MODEL 204.0 /2, 212, 218 with CODE (414) Power glass tilting/sliding roof

P77.20-2649-04

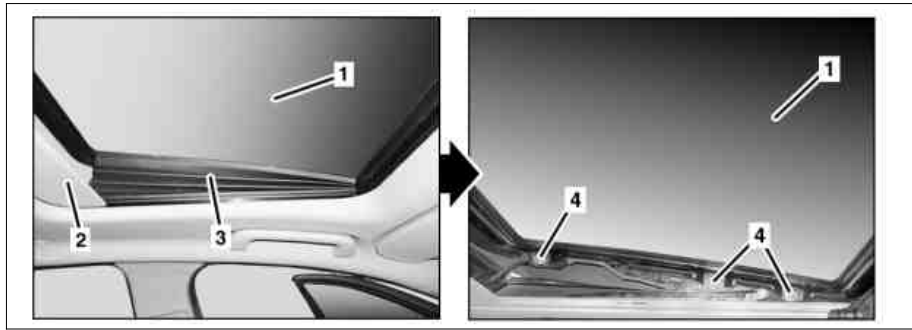
23.9.09	Tightening sequence modified	Steps 4 and 5	
---------	------------------------------	---------------	--
